**CALIFORNIA REGIONAL WATER QUALITY CONTROL BOARD  
SAN FRANCISCO BAY REGION**

**RESPONSE TO WRITTEN COMMENTS**

On Amendment to Add PCBs Waste Discharge Requirements for  
Municipal and Industrial Wastewater Discharges of Mercury to San Francisco Bay  
("Tentative Order")

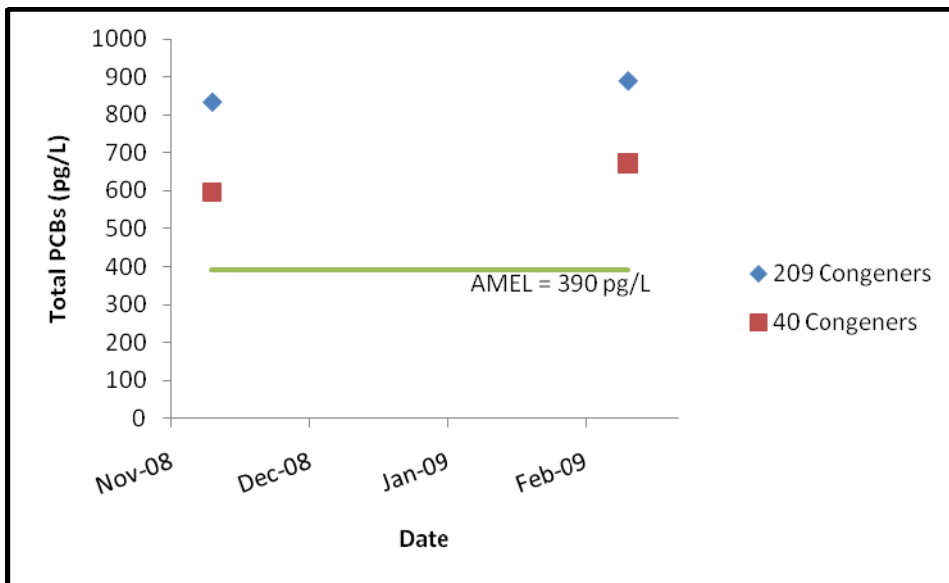
On compliance infeasibility, Palo Alto indicates that the TO includes a proposed AMEL of 0.00039  $\mu\text{g/L}$  (390  $\text{pg/L}$ ) and a proposed MDEL of 0.00049  $\mu\text{g/L}$  (490  $\text{pg/L}$ ) for the City. Several effluent samples were collected by the City subsequent to development of the TMDL for informational purposes. “Total PCBs” were calculated in two ways based on the results of 1668a analyses: first, as the sum of all 209 congeners, and secondly, as the sum of the 40 congeners typically measured by the RMP. Despite the use of the 99% upper confidence limit on the mean of the data set in the calculation of effluent limits, the two data points were well above the proposed AMEL, as shown in **Figure 1**, below.

*Although these data are also limited, Figure 1 illustrates that (1) it cannot be concluded that the AMEL is representative of current performance, and (2) “Total PCBs” values resulting from the summation of different sets of congeners are not comparable.*

Finally, we do not agree with Palo Alto's assertion that compliance with the proposed effluent limits is infeasible. In its comments, Palo Alto shows two post-TMDL data points that indicate effluent concentrations well above the average monthly effluent limitation proposed in the Tentative Order. In its assessment, Palo Alto included estimated concentrations when it calculated the effluent concentrations. However, consistent with regulations, the Water Board does not and would not use estimated values to evaluate compliance with effluent limits (see section VI Compliance Determination of Order No. R2-2007-0077). Without the estimated values, Palo Alto's two data points show effluent levels of 193 pg/L and 111 pg/L, which are both well below the proposed effluent limits (390 pg/L and 490 pg/L).

**Figure 1: Dry Weather Flows from Municipal Wastewater Treatment Plants**

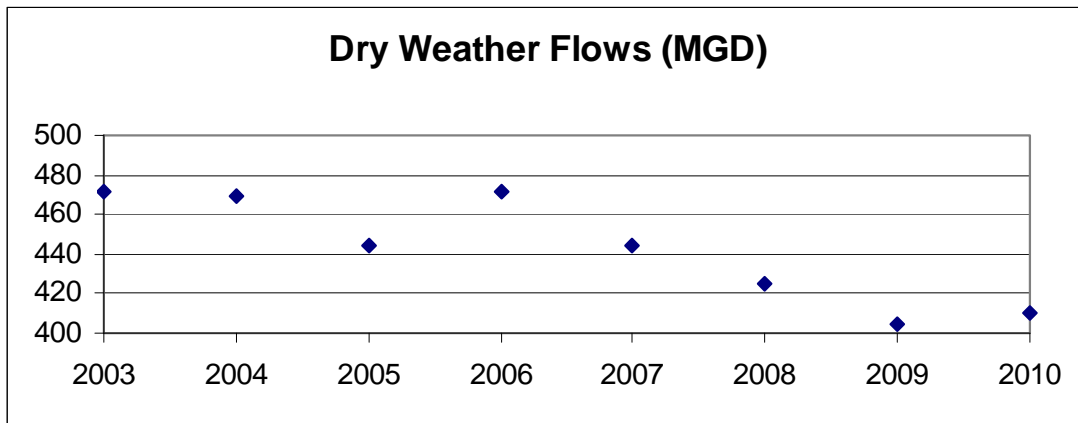
**Comment 5: (Baykeeper)** *Wasteload allocations (“WLAs”) were calculated based on the amount of flow from each discharger, and were based on sampling done ten years ago. If the dischargers have an increased amount of flow today, then the actual load could be higher than the WLA. How does the Order take into account changes in flow? It would be helpful to include flow data on each discharger in the Order, and to require the dischargers to report daily flow to the Board. This flow data should be evaluated to determine if the effluent limitations are adequate for each discharger to meet the WLA in the TMDL.*

**Response:** We have not made changes in response to this comment. On accounting for changes in flow, the Tentative Order does not specifically address this issue because with constraints in water supply and increased efforts at water conservation and water recycling, it is unlikely that any meaningful increase in treated wastewater flow to San Francisco Bay will occur. To illustrate this point, Figure 1 below shows a declining trend in municipal wastewater discharges to San Francisco Bay. These data are from nearly all of the municipal wastewater treatment plants in the Region. These dischargers report electronically and represent about 90% of total treated wastewater flow. The figure shows only flow from June through September of each year to eliminate variability from extremely wet or dry years.

While individual wastewater treatment plants may be granted small increases in flow, the TMDL is based on overall loadings to San Francisco Bay. As indicated in Figure 1, the concentration-based approach proposed in the Tentative Order is protective since overall treated wastewater flows to San Francisco Bay are not increasing and may in fact be decreasing.
